DECISION, CONDITIONS, FINDINGS OF FACT AND CONCLUSIONARY FINDINGS OF THE MCMINNVILLE HISTORIC LANDMARKS COMMITTEE FOR THE APPROVAL TO CHANGE THE APPROVED EXTERIOR BUILDING MATERIAL FROM STUCCO TO PAINTED CEMENTITIOUS PANELS WITH REVEAL JOINTS OF A NEW BUILDING AT 631 NE 1ST STREET WITHIN THE DOWNTOWN DESIGN AREA

- DOCKET:** AMENDED DDR 1-21 (Downtown Design Review for New Construction)
- REQUEST:** Approval of a Downtown Design Review application to change the approved exterior building material from traditional stucco to painted cementitious panels with reveal joints for the construction of a new building at 631 NE 1st Street on a parcel that is currently vacant and approve proposed exterior building colors. The proposal includes a request for a waiver to allow cementitious panels as building material.

- LOCATION:** 631 NE 1st Street. The property is identified as Tax Lot 11300, Section 21BC, T. 4 S., R. 4 W., W.M.
- ZONING:** C-3 (General Commercial)
- APPLICANT:** Amy & Silas Halloran-Steiner (property owners)

Figure 4. Figure 2. West (Side) and East (Side) Facing Elevations Rendering

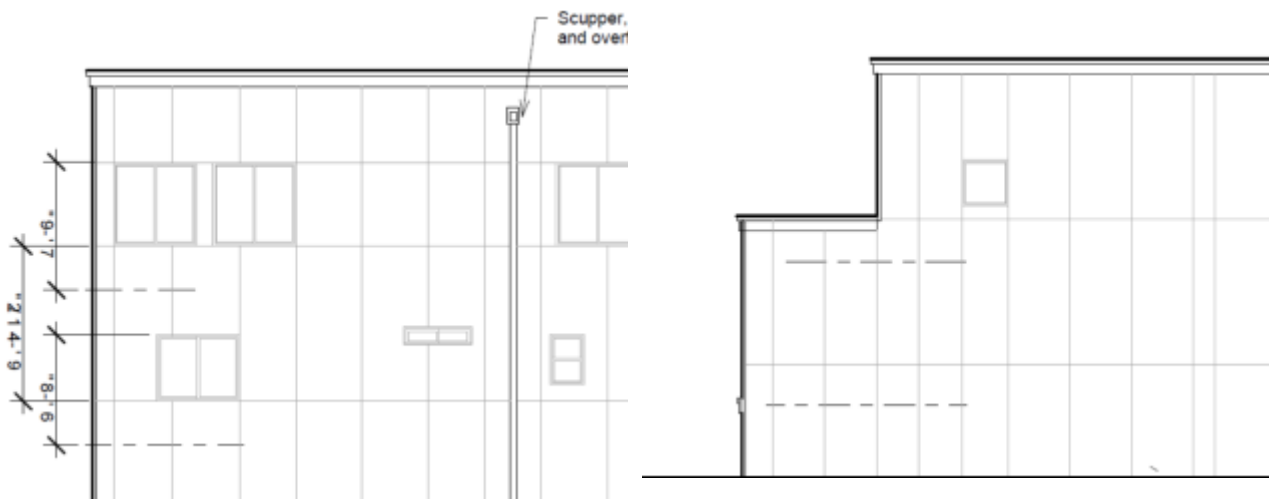
The HLC believes that the proposed cementitious panels are similar in appearance to stucco, which is an approved material in the downtown design overlay, but had concerns about the system’s reveal joints between the panels. The committee elected to allow the reveal joints as proposed on the non-public facing facades, but required that the public-facing façade (1st Street façade) be required to use flangeless joints on the vertical sides of the panels where the system allows.

The third story of the First Street is recessed back from the front façade of the first two stories. This is to accommodate a private patio area for the residential use. Since it will not be as visible from the street, the third story of the First Street façade can be treated in the same manner as the non-public facades.

The first two story of the building is more prominent and visual to the public. Having flangeless vertical reveal joint trim would be similar to stucco joint, Therefore, a condition is necessary.

Conditions for Finding: The vertical reveal joint trim of the painted cementitious panels of the first two stories of the southside of the building (First Street) shall be flangeless

Outside corner details of the painted cementitious panels and reveal joint trim shall be submitted for approval by staff and Historic Landmarks Committee Chair prior to installation of panels and joint trim.
